**NEI 99-02 FAQ 14-02
Fort Calhoun MSPI**

Plant: Fort Calhoun Nuclear Station

Performance Indicator: MS06 Mitigating System Performance Index (Emergency AC Power Systems)

FAQ 14-02: FCS MSPI Validity

EAC	Q12014	Q22014	Q32014	Q42014	Q12015
MSPI	-2.4E-08	2.7E-07	3.0E-07	1.2E-06	9.2E-07
UAI	-9.50E-09	2.86E-07	3.31E-07	7.11E-07	6.92E-07
URI	-1.49E-08	-1.31E-08	-3.18E-08	4.66E-07	2.32E-07
% Baseline Crit Hrs	9.7%	18.7%	27.8%	35.6%	45.8%

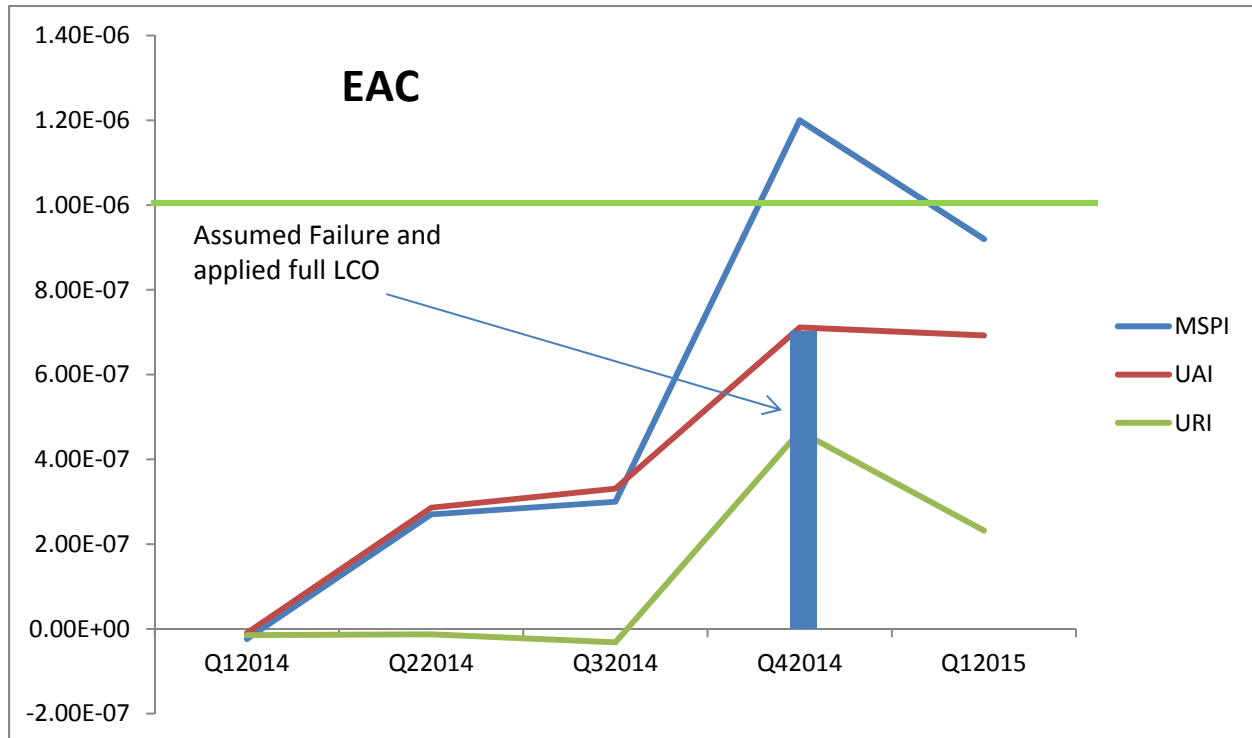
In this FAQ, the licensee, FCS, proposes that the High Pressure Safety Injection (HPSI) system MSPI, Heat Removal System (HRS) MSPI, and Cooling Water System (CWS) MSPI become valid on the 4th quarter of 2014. However, FCS proposes that the Emergency AC (EAC) power and Residual Heat Removal (RHR) system MSPI indicators become valid on the 1st quarter of 2015 and 1st quarter of 2016, respectively.

FCS predicted future MSPI values using a Pressurized Water Reactor Owners Group “What-if” tool and expected plant data for unavailability and unreliability. These estimated MSPI values defined the licensee’s proposal of the respective effective dates for each MSPI indicator to become valid. The NRC staff agrees with the proposal for the HPSI, HRS, and CWS MSPIs to become valid on 4Q2014, and for the EAC MSPI to become valid on 1Q2015. However, the NRC staff does not agree with the proposal for the RHR MSPI to become valid on 1Q2016.

The NRC staff concludes that: (1) the HPSI, HRS, and CWS MSPIs should become valid on 4Q2014, and (2) the EAC and RHR MSPIs should become valid on 1Q2015.

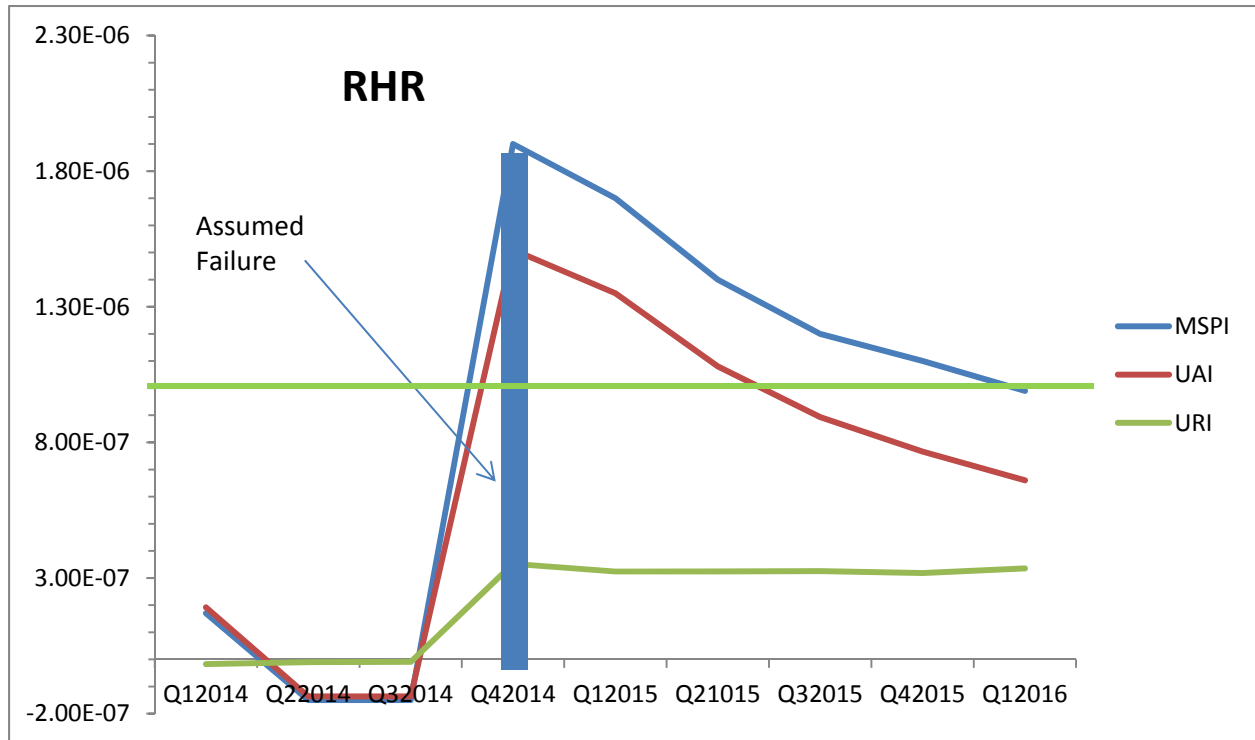
The staff recognizes that the approach to maintain the RHR MSPI indicator invalid before 9 quarters of operational data have been accrued proactively prevents the indicator from resulting in a false positive due to accrued unplanned unavailability. However, various factors such as increase in inspection resources, aggregation of various inputs to the indicator, alignment with previously established positions, and external stakeholder communications should also be taken into consideration when defining an effective date for the indicator to become valid.

- Having the RHR MSPI invalid before 9 quarters of data have been accrued will increase inspection resources. While a baseline inspection approach would be applied to all other systems covered by MSPIs, additional inspection hours would have to be implemented to gain performance insights on the RHR system.

- Having the RHR MSPI invalid before 9 quarters of data have been accrued limits the indicator from providing insights on RHR performance based on the estimated outcome of accrued unplanned unavailability. It does not allow the indicator to provide insights on RHR performance that might result from any other failures and/or unavailability observed under this indicator.

- The approach of having the RHR MSPI invalid before 9 quarters of data have been accrued results in a significantly different treatment from that used for the other MSPIs. It also diverges noticeably from the starting point for evaluation of such situation that was discussed through white papers in the ROP WG (ADAMS Accession No. ML13079A728), and the initial characterization of this FAQ. Such divergent approach can impact the overarching ROP goals of understandability and predictability.

- Having the RHR MSPI invalid before 9 quarters of data have been accrued while all other MSPI indicators are treated as valid performance indicators can present communication challenges to external stakeholders. Such unique approach would impact the clarity of the performance indicator program.

Since historical data on RHR unplanned unavailability was not considered, accounting for the Technical Specifications (TS) Allowed Outage Time (AOT) (i.e., 7 days) could be a highly conservative estimate. If an indicator is really “invalid” for 9 of a total of 12 quarters (75%), what other types of implications can be inferred? Although TS SSCs in general make-up the list of monitored components in MSPI, the AOTs, surveillance frequencies, etc. do not necessarily correlate with risk importance (i.e., maybe TS AOTs is not a good input to use for a risk-based calculation).
